OFFICE OF THE COUNTY ENGINEER

SUBJECT: Comments on the Final Environmental Impact Statement (FEIS) for the North Houston Highway Improvement Project (NHHIP)

DATE: December 8, 2020
TO: John R. Blount, P.E.
FROM: Loyd Smith, P.E. 
SUBJECT: **Response to Final Environmental Impact Statement for Proposed North Houston Highway Improvement Project**

Re: Review of TxDOT Responses to HCED DEIS Comments

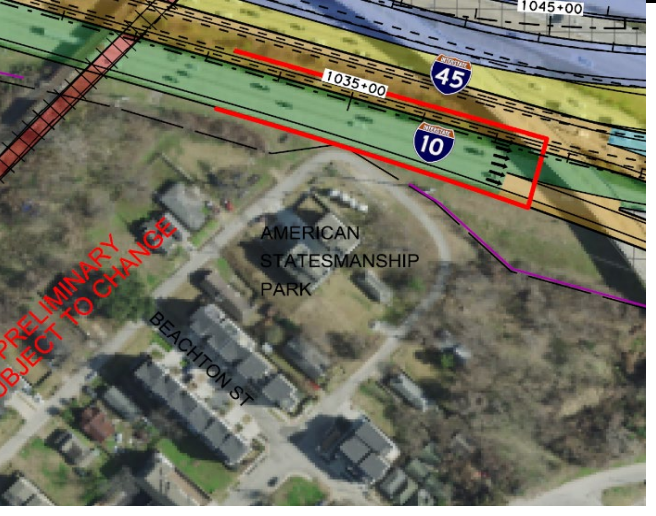
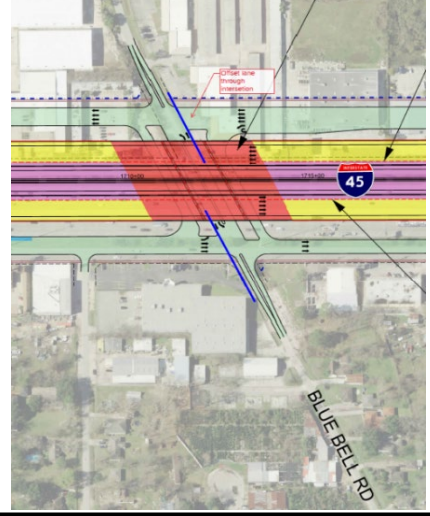
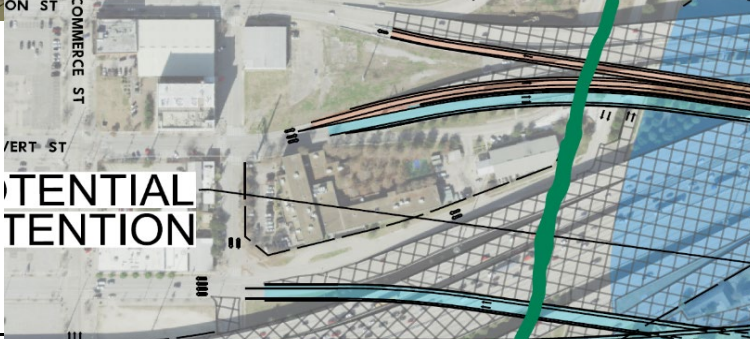
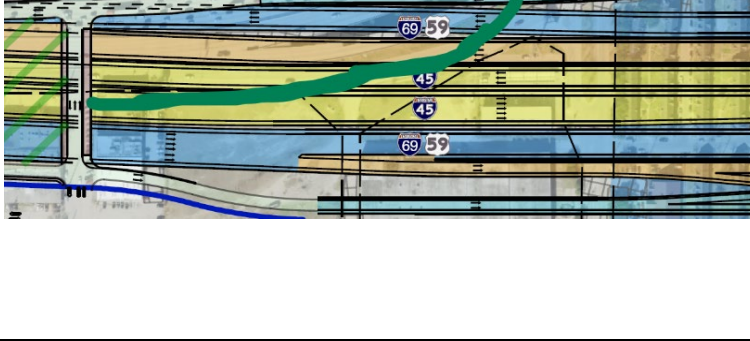
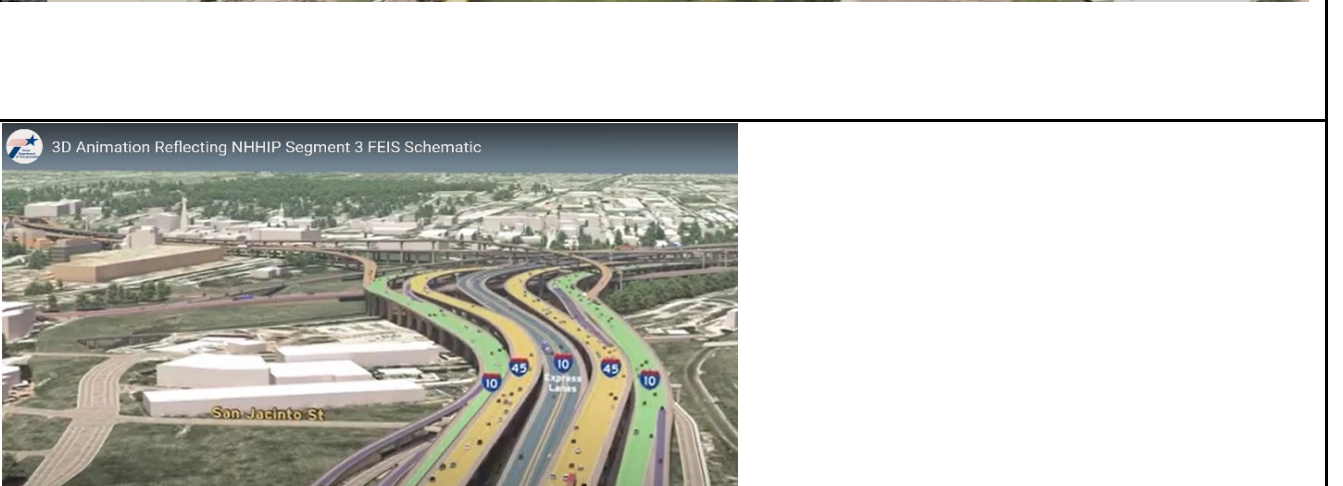
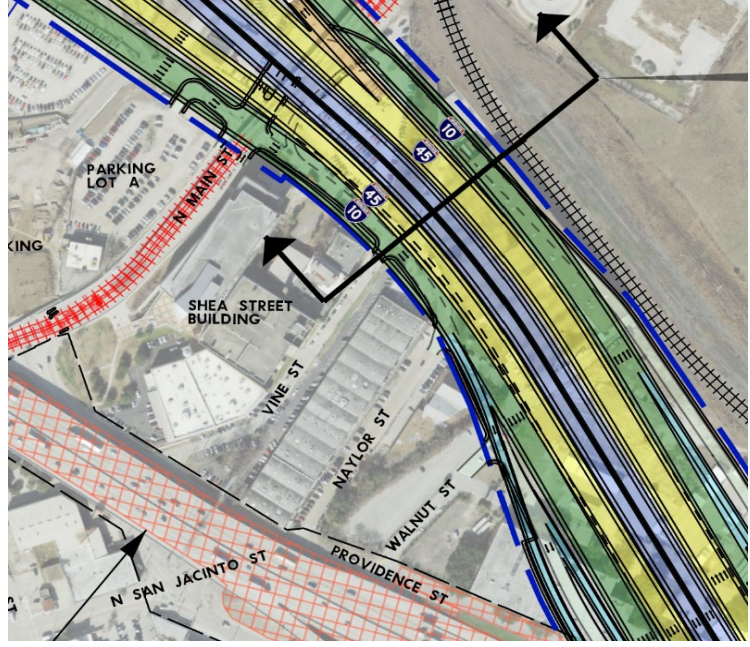
- The NHHIP project would move the highway alignment further north – where it no longer intersects with the existing terminus of San Jacinto Street – and the schematics do not show San Jacinto being extended to meet the new freeway. The only existing street extending to the freeway from the current terminus of San Jacinto in this area would Walnut Street. There is a street labeled Naylor

Street in the NHHIP schematic but according to Harris County Appraisal District the alignment appears to be entirely on private right of way. Both Walnut Street and the segment labeled Naylor Street are narrow alley-like corridors that primarily function as driveways to local buildings.

- The schematics show both Walnut street and Naylor connecting only to the eastbound frontage road, whereas San Jacinto currently extends across the highway to the westbound frontage road (Providence Street) and beyond. While it would be possible to extend San Jacinto to meet both frontage roads (crossing the proposed highway), this does not seem to be included in the project design or budget, nor does it show how this would work with a proposed San Jacinto underpass connection to the northside. This extension would also likely require acquisition of right-of-way that does not appear to have been documented in the FEIS. Extending San Jacinto to the westbound frontage road and also to the Near Northside should be considered as part of the design and implementation of Segment 3.

- Construct local streets, including San Jacinto Street, north of Downtown, that will be required to be reconstructed or extended due to realignment of the highway. At minimum, San Jacinto should be extended to meet the westbound highway frontage road. The commitments should also include the acquisition of any necessary right-of-way to extend San Jacinto to, or beyond, the westbound frontage road.

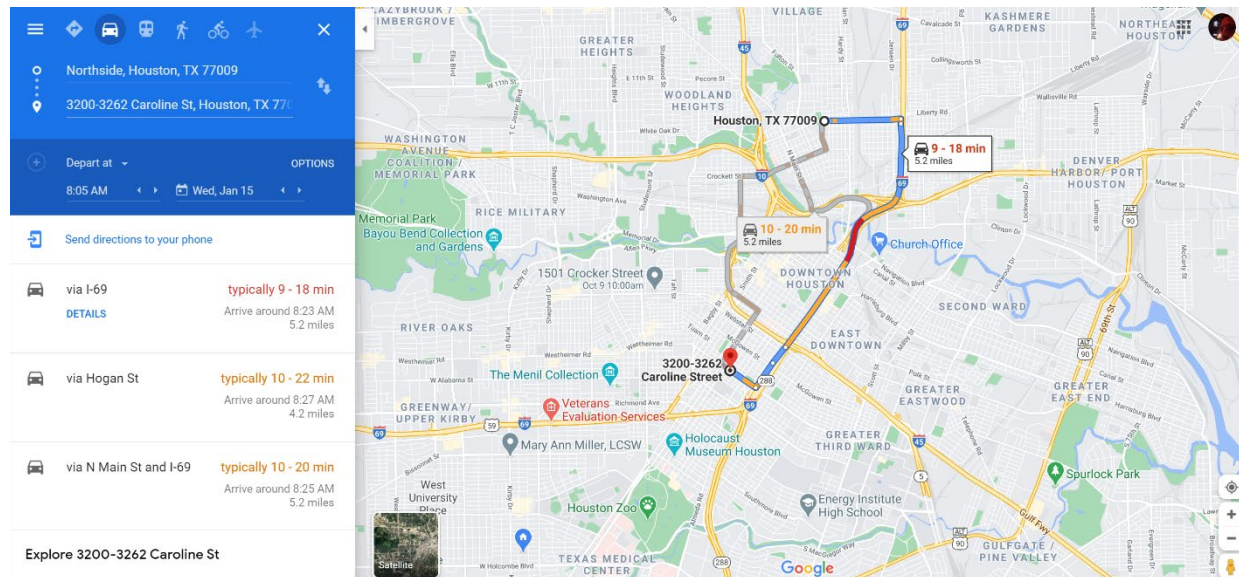
- i. The estimated travel times for no build are not reasonable;
 - 1. Examples of these trips are shown in the Travel Time Table below which was provided in the [NHHIP Project Facts & Highlights](#).

2. As driving trip speeds drop significantly, driving trip demand will also decline or people will choose different, faster modes to make their trip; Travel Demand Models often do not factor this into the modeling assumptions accurately.

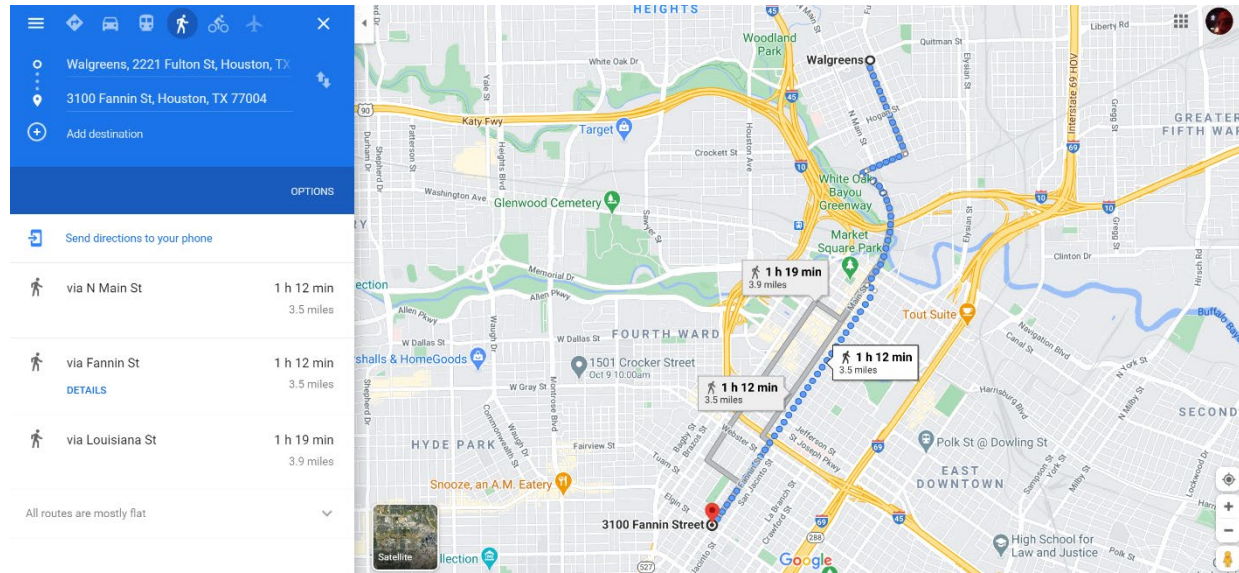
1. This trip is assumed to take 103 minutes in the No Build and 16 minutes with the NHHIP.
 2. Because exact locations are not provided by the Table, we can compare at a trip from the intersection of Fulton at Quitman in Near Northside to the intersection of Caroline at Elgin in Midtown which are both central to their respective districts.

3. Existing driving trip travel times from Google Maps in January 2020 are estimated to take 9-18 minutes and cover a distance of 5.2 miles. As the crow fly distances between these two points is 3 miles.

4. The No Build travel time assumption of 5.2 miles in 103 minutes would imply a travel speed of 3 mph.
5. According to Google Maps, making this trip via walking would take 31 minutes less (72 minutes vs. 103 minutes).

Section 2) Base line model Assumptions for traffic growth have not been supported by actual data.

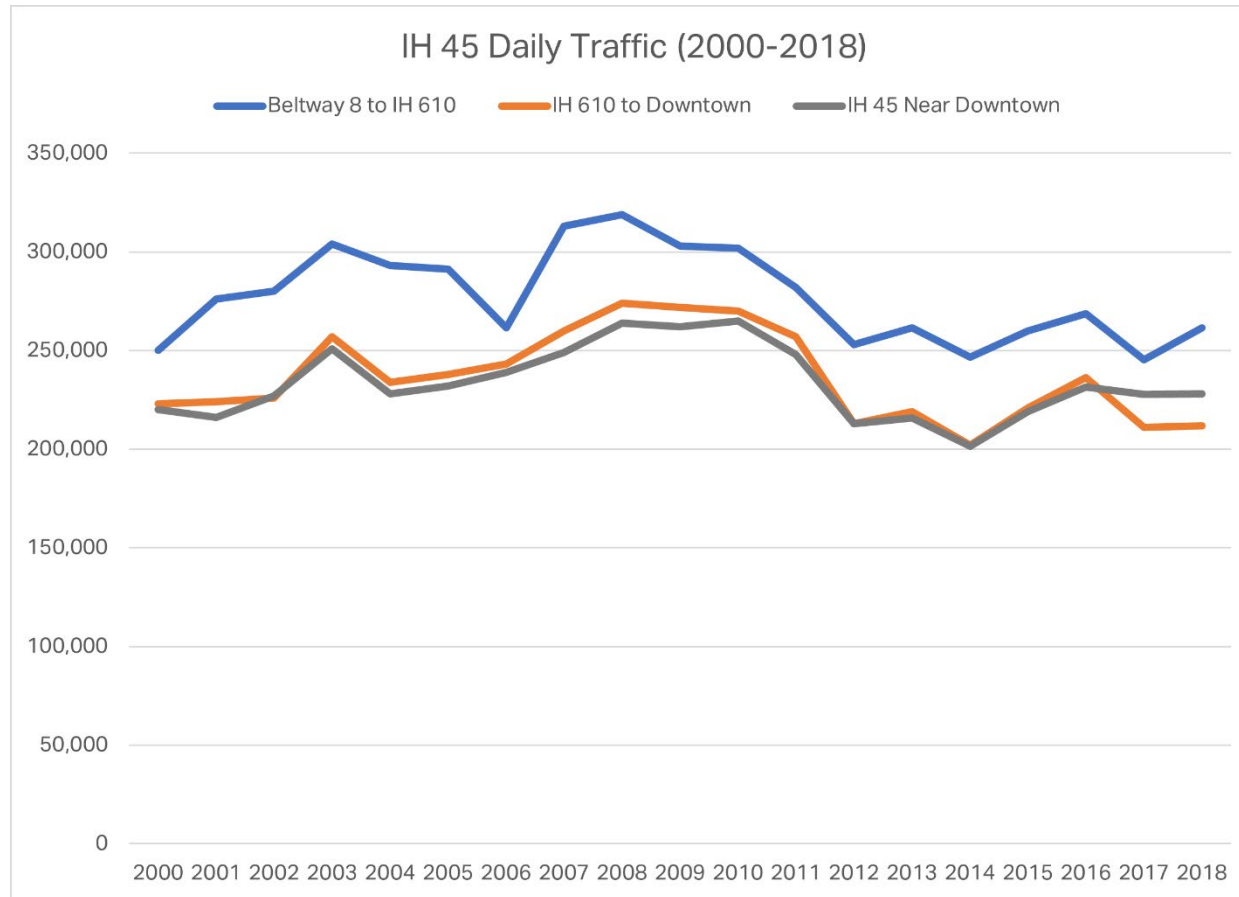
a. Traffic volumes on IH 45 have been essentially flat for two decades; (Source: TxDOT Statewide Planning Map Data)

- i. Beltway 8 to IH 610 (0.2% Compound Annual Growth Rate (CAGR))
- ii. IH 610 to Downtown (-0.3% CAGR)
- iii. IH 45 at Downtown (0.2% CAGR)

Blue Bell Road

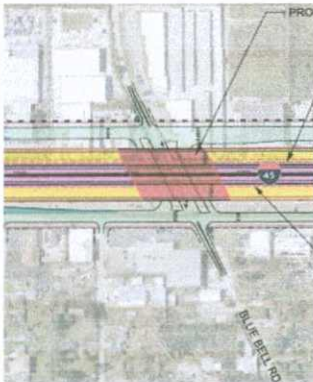
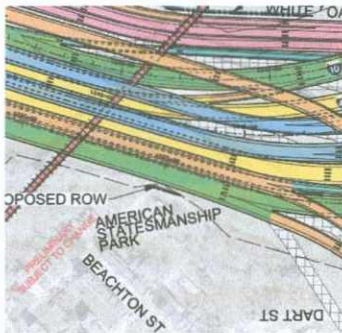
However, the schematic at **Blue Bell Road** shows only one eastbound lane and one westbound lane passing under the I-45 bridge, without a dedicated left turn lane in either direction. This design is typical at rural underpasses with low volumes. To accommodate expected traffic demand and to reduce signal delays, we request that the Blue Bell Road cross-section be revised to at least four lanes under I-45. The

turnouts and the connecting roadways to the east and the west should also be widened to match, with multiple lanes approaching the intersection from the east and west.

The I-10 ramp configuration near North San Jacinto Street has negative impacts to drivers accessing the regional freeway system

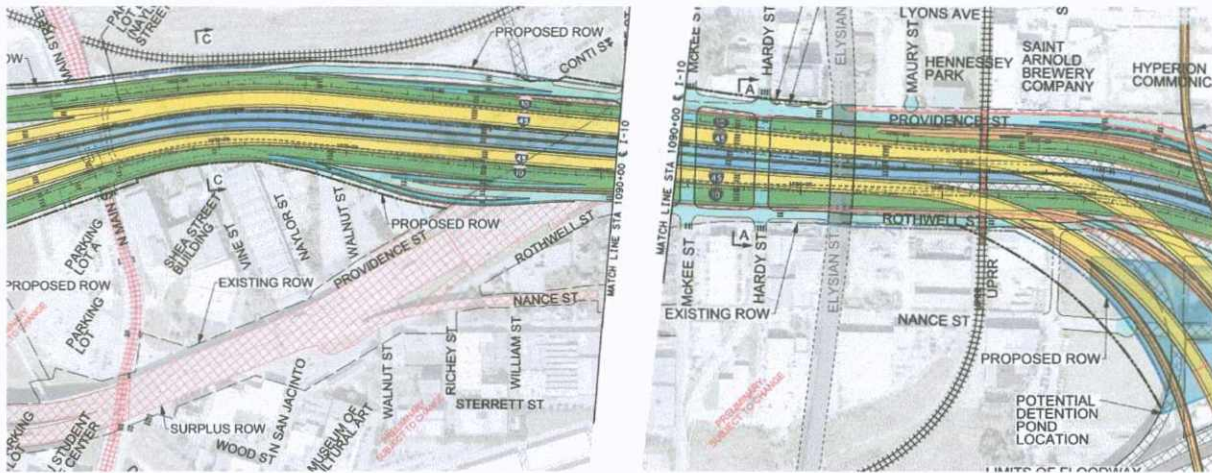
Currently, the North San Jacinto route into downtown easily connects to multiple freeways via the Main Street / North San Jacinto / Nance Street ramps on I-10. The ramps being proposed to serve this area do not provide equivalent access.

- The I-10 westbound exit ramp to the surface street network has been relocated to east of the Hardy Street / McKee Street one-way pair, which will require all exiting vehicle to immediately pass through a traffic signal or all-way stop sign control at each of the two intersections.

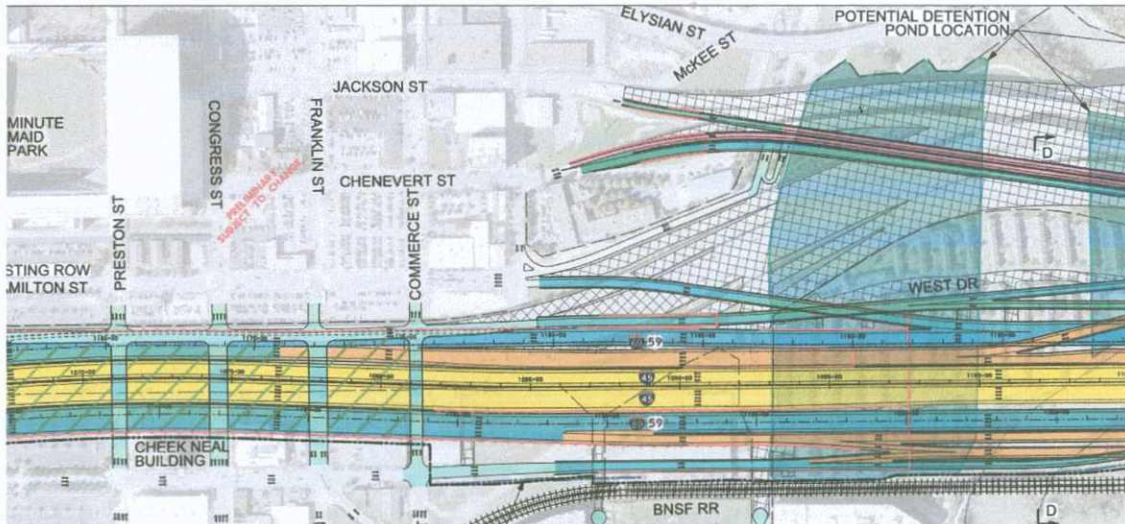
Currently there are three eastbound lanes of Franklin Street passing under I-69, two through lanes and a dedicated left turn lane. It appears that only two eastbound through lanes are provided in the schematic design prepared by TxDOT, creating the appearance that Franklin Street will connect only to Navigation Boulevard. This would be a result with excessive negative impacts to all drivers in the area.

The schematic shows proposed Franklin Street construction will end short of the St. Emanuel intersection, where eastbound drivers will expect to make a left turn to access the freeway entrance

ramps to the north. In its current configuration, however, a raised median serves to prohibit those eastbound left turns.

There are clearly fundamental deficiencies in the Franklin street design details. These should be re-evaluated and corrected.
